# Environmental Impact Statement

## Getty and Cities Service Shale Oil Projects

**FINAL**

**5 October 1984**

Figure 2.3-20 Plot Plan for Surface Facilities, Cities Service Shale Oil Project.

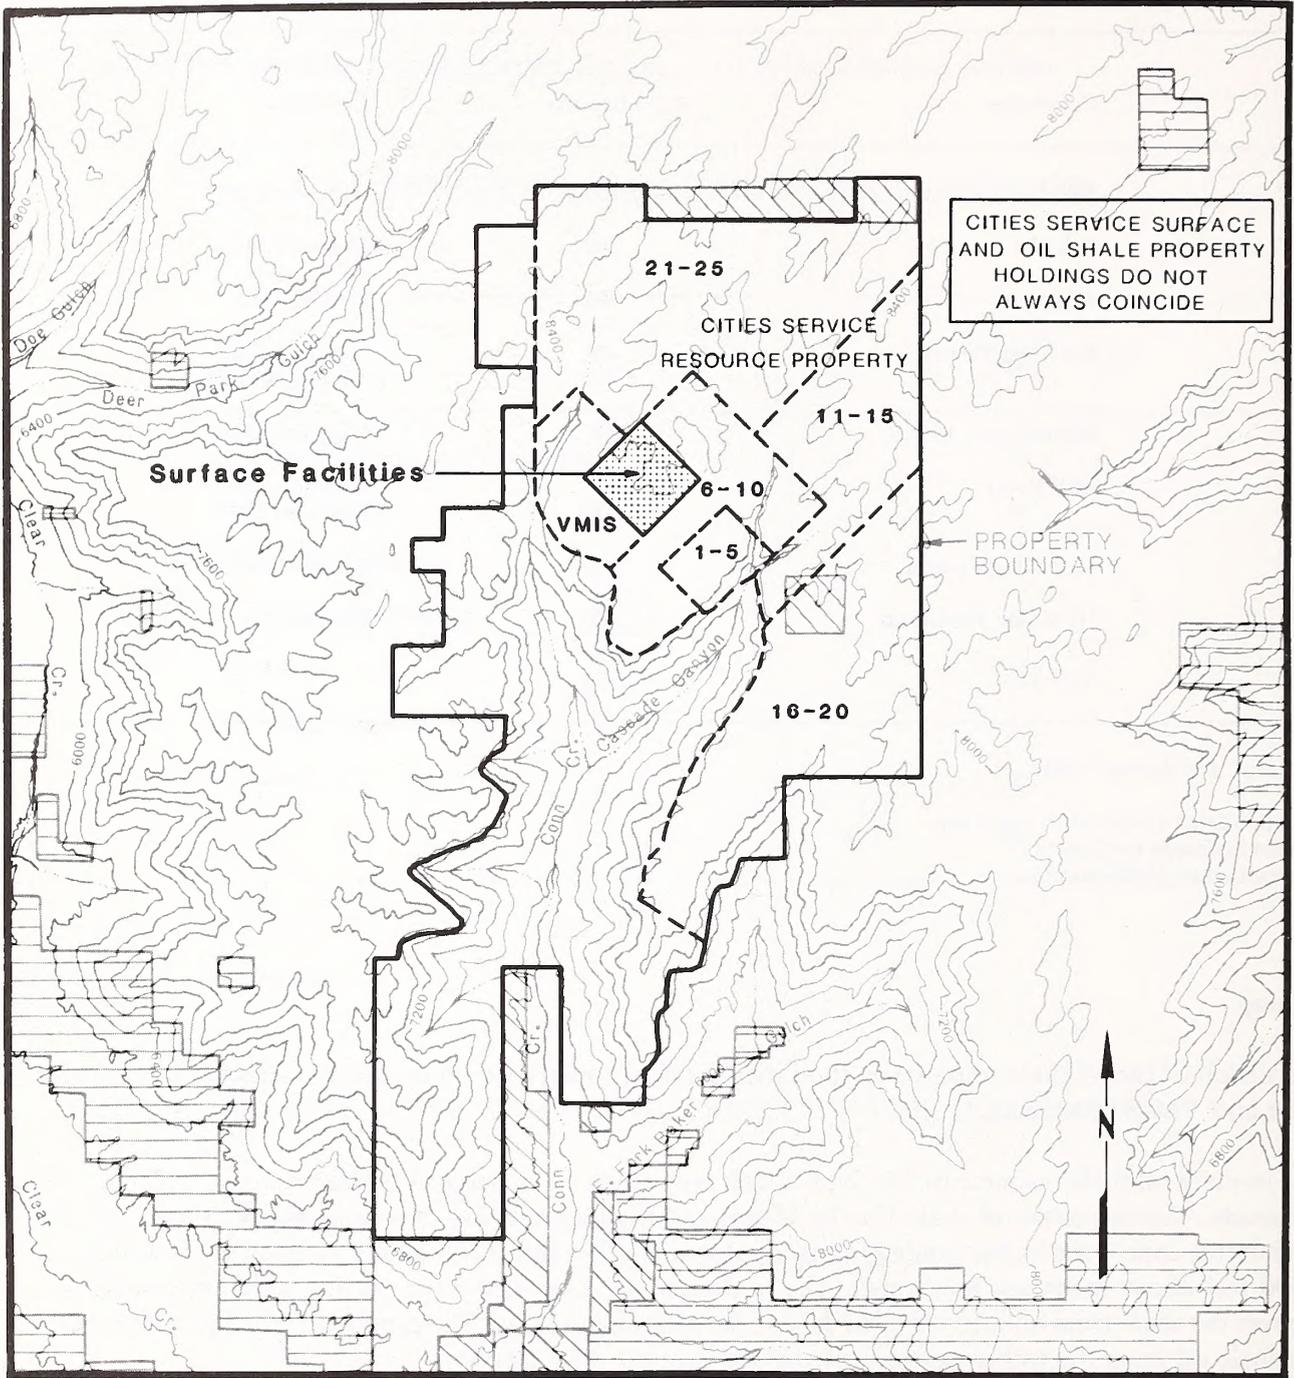
Page 2-72, Figure 2.3-20, the line showing the location of the crushing and screening facilities should be extended further north to also include the facility due north of the indicated facility.

Figure 2.3-25 Conceptual Diagram of the VMIS Retort Process, Cities Service Shale Oil Project.

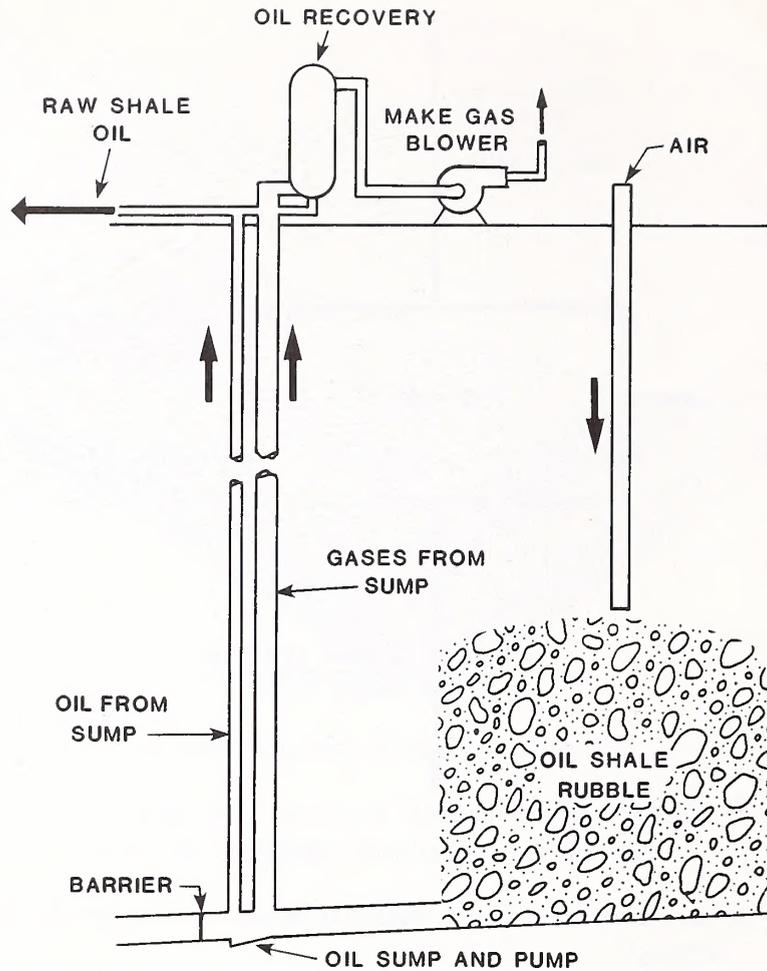
Page 2-79, Figure 2.3-25, "Source: Cities (1984b)", should be "Cities Service (1983b)".

Figure 2.3-33 Sulfur Control Systems, Cities Service Shale Oil Project.

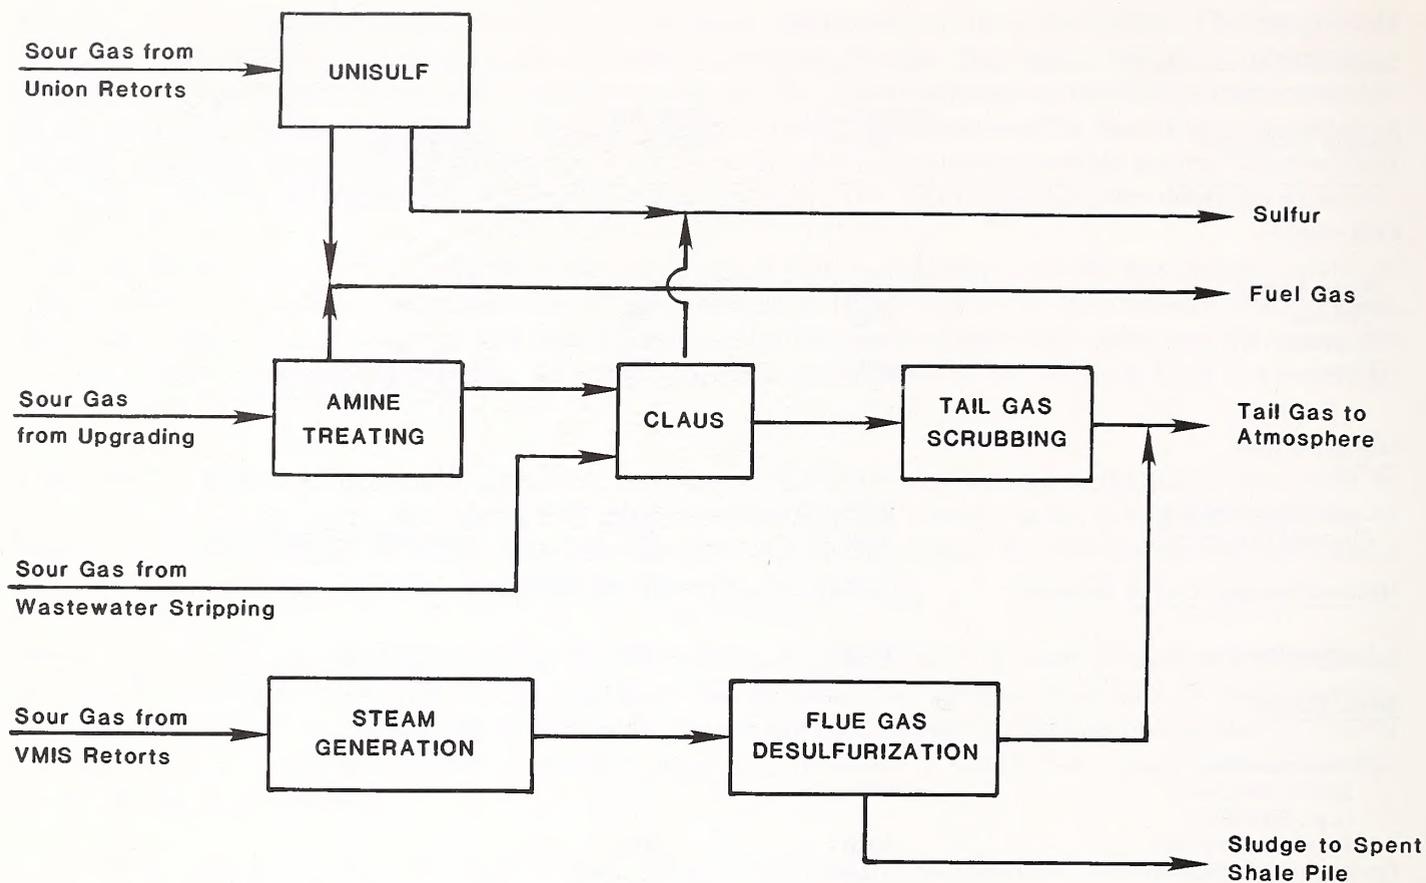
Page 2-103, Figure 2.3-33, the reference "Cities Service/Getty (1984a)" should read "Cities Service/Getty (1984b)".
